SUBMISSIONS REPORT

Tilbuster Solar Farm

Project Number: 20-729

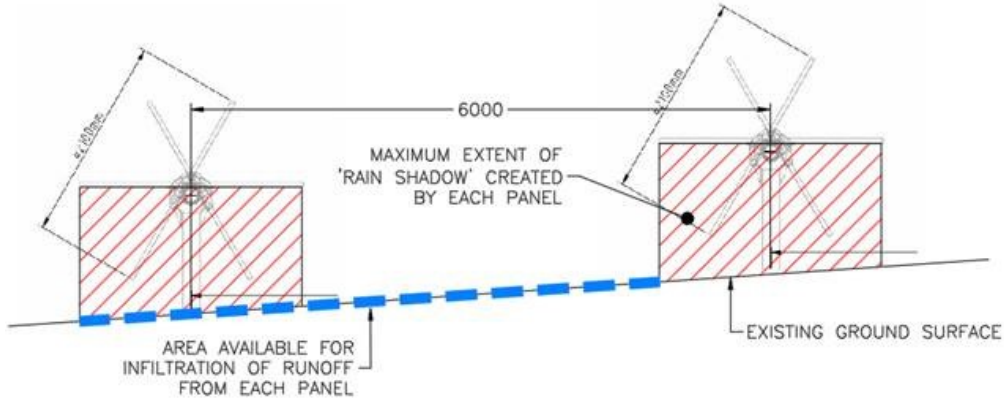
Waste Generation	<p>Concern as to the capacity Council's landfills will have space, given that the region is experiencing substantial growth in new developments. Council would like a focus to be on separating recycling and landfill waste and recommend that any consent should require submission of a waste management plan, outlining all waste management principles</p>	<p>Section 8.10 of the EIS addresses waste management and provides a full list of mitigation measures, which require the Proponent to develop and implement a Waste Management Plan (WMP). The WMP will be developed preconstruction as part of the Construction Environmental Management Plan to be submitted to DPIE. The WMP would include the identification of opportunities to avoid, reuse and recycle, in accordance with the waste hierarchy.</p> <p>Section 8.10 of the EIS outlines what wastes would be produced during to construction, and how the waste would be managed. These include:</p> <ul style="list-style-type: none"> Identification of opportunities to avoid, reuse and recycle, in accordance with the waste hierarchy. Quantification and classification of all waste streams.

Issue	Detail of issue	Proponent response
	and practices relevant to the proposal to reduce waste and recover resources.	<ul style="list-style-type: none"> • Provision for recycling management onsite. • Provision of toilet facilities for onsite workers and identify that sullage would be disposed of (i.e., pump out to local sewage treatment plant). • Tracking of all waste leaving the site. • Disposal of waste at facilities permitted to accept the waste. • Requirements for hauling waste (such as covered loads). <p>Separation of waste would occur in accordance with waste hierarchy principles.</p> <p>Therefore, no changes to the proposal or mitigation measures are proposed in response to this concern.</p>
Land Contamination	Local level concerns with regards to potential contamination of land and water courses in the event of faulty/damaged/or deteriorating panels, particularly after storm, bush fire events or other significant events. These matters should be addressed in an OEMP.	<p>Risk of Contamination</p> <p>The energy producing part of solar panels contain a mix of metal components and silicon. These components are enclosed in glass and are not able to mix with air or water in the atmosphere. Therefore, there is negligible risk of chemical release from a solar panel. Typically, PV panels are made of tempered glass. Solar panels pass tests that simulate common environmental conditions and events, such as hail.</p> <p>A study on the potential for leaching of heavy metals and metalloids from crystalline silicon PV systems from the Journal of Natural Resources and Development (Robinson & Meindl, 2019) was conducted to determine whether potentially toxic elements could have the potential to leach into the surrounding environment. Soils were analysed from beneath panels against a control site, away from panels. This was done to determine if soils were being enriched by metals such as lead, cadmium, lithium, strontium etc. and metalloids such as selenium.</p> <p>The results of the findings concluded that there were no significant differences in lead or cadmium levels, with only minor concentration differences in other metals between soil samples under PV panels and the control sample. Despite the minor concentration differences, there would be negligible risk to nearby ecosystems and therefore negligible risks to residences or to current (proposed) or future farming activity.</p> <p>Bushfire</p> <p>Bushfire management is addressed in Section 8.7 of the EIS. As part of this assessment, 14 safeguards have been developed that will avoid, minimise and mitigate bushfire impacts. This includes the preparation of a detailed bushfire management plan in accordance with safeguard BF3 in the EIS.</p> <p>The implementation of these safeguards is expected to dramatically reduce the risk of fire damage to solar infrastructure. However, in the unlikely event damage occurs, this will be managed in accordance with the Spill and Contamination Response Plan, identified in safeguard LS5 of section 7.3.5. of the</p>

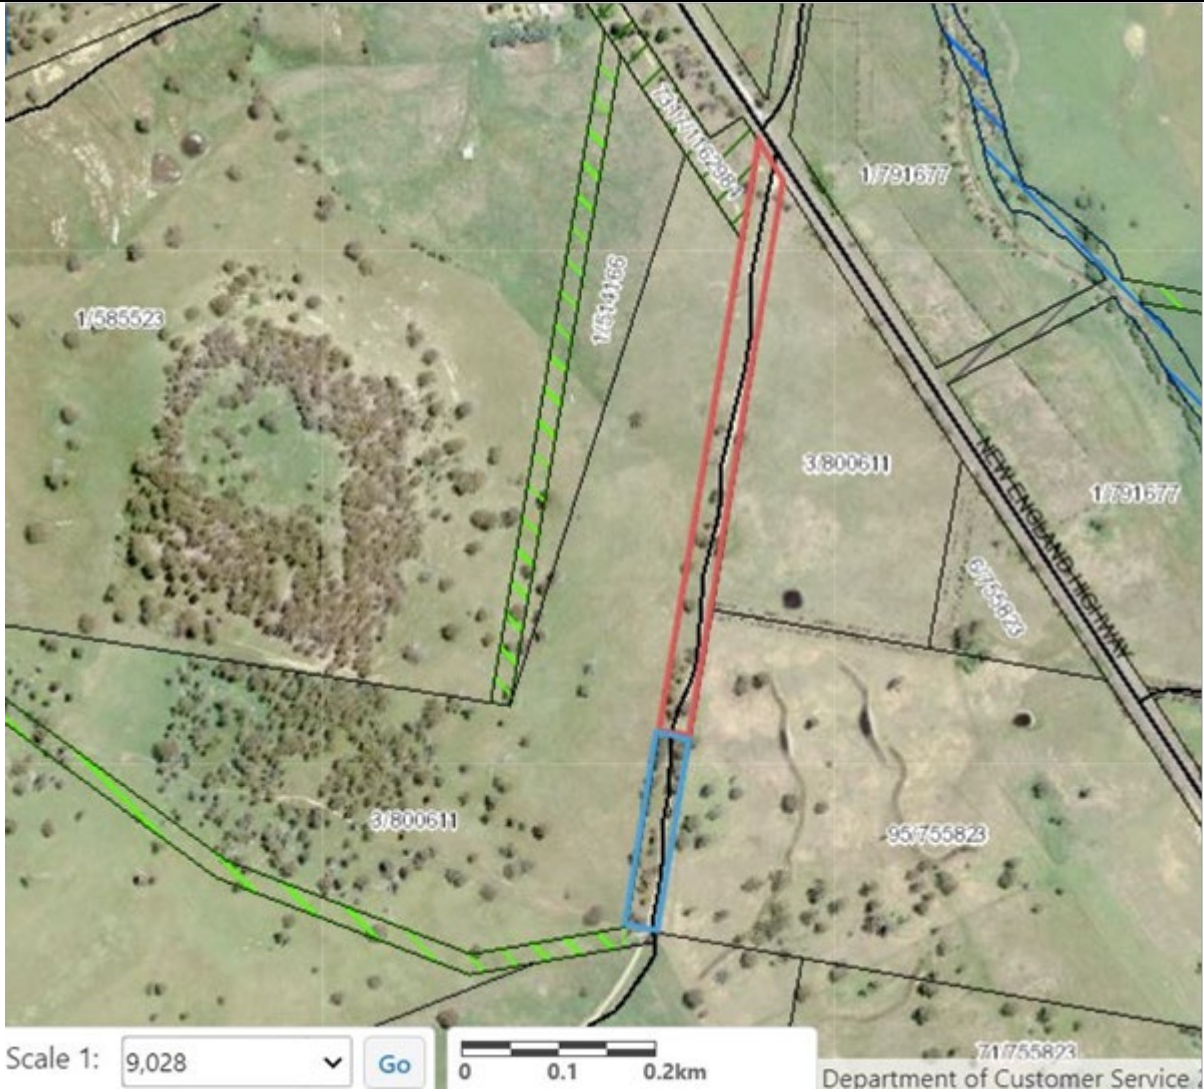
SAII (f) The assessor is required to determine, as accurately as possible, the extent of the CEEC in the NSW reserve system in the IBRA bioregion and subregion. While we acknowledge that there is a paucity of data to easily determine this, we suggest examining plans of management for the reserves located within these areas to determine if the	Where such information was available for the reserve system, details have been added to the BDAR.

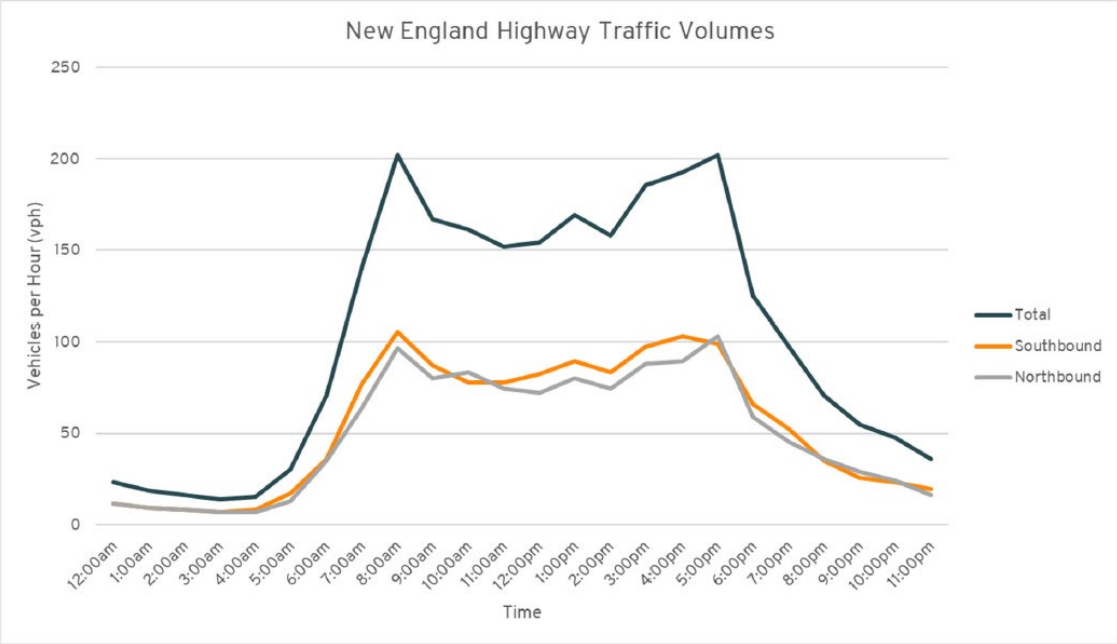
Issue	Detail of issue	Proponent response
	the watercourse.	
DPI Agriculture		
Soil and Land Assessment	<p>The EIS notes the commitment to a baseline soil survey prior to consultation to inform the CEMP and sub plans, rehabilitation and operational aspects of soils and groundcover management. It is important that the pre-development land and soil capabilities that can be measured can at least be attained at the current level or better with the closure and rehabilitation of the solar farm.</p> <p>The benefits of 'resting land' are discussed in the EIS. To achieve these claims groundcover types, quantities and management, soil chemical and moisture testing, including organic matter are all parameters that can be measured to substantiate the major outcomes of the solar farm's land resting phase. These should be reported on annually to every three years (depending on the parameters). (page 254-5).</p>	<p>The EIS commits to soil survey prior to construction and are covered in sections 7.3 and 7.4 of the EIS. Relevant mitigation measures include:</p> <ol style="list-style-type: none"> 1. Undertake a base line soil survey prior to construction to inform the CEMP and sub-plans, rehabilitation and operational aspects of soil and groundcover management. <p>As part of the CEMP, and in accordance with safeguard B2 in the EIS, a Soil and Water Management Plan (SWMP) (with erosion and sediment control plans) would be prepared, implemented and monitored during the proposal, in accordance with Landcom (2004), to minimise soil (and water) impacts. These plans would include provisions to:</p> <ul style="list-style-type: none"> • Install, monitor, and maintain erosion controls. • Ensure that machinery leaves the site in a clean condition to avoid tracking of sediment onto public roads which may cause risks to other road users through reduced road stability. • Manage topsoil in all excavation activities, separate subsoils and topsoils and ensure that they are replaced in their natural configuration to assist revegetation. Stockpile topsoil appropriately so as to minimise weed infestation, maintain soil organic matter, maintain soil structure and microbial activity. • Minimise the area of disturbance from excavation and compaction; rationalise vehicle movements and restrict the location of activities that compact and erode the soils as much as practical. Any compaction caused during construction would be treated such that revegetation would not be impaired. • Manage works in consideration of heavy rainfall events; if a heavy rainfall event is predicted, the site should be stabilised, and work ceased until the wet period had passed. • Areas of soil disturbed by the Proposal would be rehabilitated progressively or immediately post-construction, reducing views of bare soil. <p>An ongoing soil monitoring program throughout the operation phase of the proposal that incorporates yearly soil surveys is considered unwarranted and unfeasible. However, baseline soil monitoring will be completed in accordance with safeguard LS1 of the EIS, and a Groundcover Management Plan will be prepared in accordance with safeguard SL3 of the EIS. These measures will prevent soil loss and maintain groundcover. In addition, and in accordance with safeguard LS8 in the EIS, a Rehabilitation Plan would be prepared to ensure the array site is returned to at least or better than pre-solar farmland and soil capability. The plan would be developed with reference to the base line soil testing and with</p>

Issue	Detail of issue	Proponent response
		<p>input from an agronomist to ensure the site is left stabilised, under a cover crop or other suitable ground cover. The soil survey would be based on:</p> <ul style="list-style-type: none"> • <i>Australian Soil and Land Survey Handbook</i> (CSIRO, 2009) • <i>Guidelines for Surveying Soil and Land Resources</i> (CSIRO, 2008) • <i>The land and soil capability assessment scheme: second approximation</i> (OEH, 2012) <p>No changes to the proposal or mitigation measures are proposed in response to this concern.</p>
Groundcover and Weed Management	<p>The Groundcover Management Plan development in consultation with an agronomist to ensure perennial pasture is maintained across the site, is noted. Weed control will form part of this planning.</p> <p>A pest and weed management plan will also be developed with Armidale Regional Council and NSW DPI. This should also involve the New England Weeds Authority who deal with noxious and other priority weed species in the area. This should be considered in relation to the Groundcover Management Plan where a weed management procedure can be developed to prevent and minimise the spread of weeds that are noxious, priority, environmental etc.</p>	<p>Safeguard LS9 of the EIS commits to the preparation of a Pest and Weed Management Plan in accordance with Armidale Regional Council and NSW DPI requirements.</p> <p>The New England Weeds Authority will be included in the development of the Groundcover Management Plan and the Weed management procedure.</p> <p>This recommendation now forms a commitment of the Proposal. Safeguard LS9 will be updates as follows (additional text underlined).</p> <p>LS9 A pest and weed management plan would be prepared to manage the occurrence of priority weeds and pest species across the site during construction and operation. The plans must be prepared in accordance with Armidale Regional Council and NSW DPI requirements. <u>The New England Weeds Authority will be consulting during the development of the plan.</u></p>
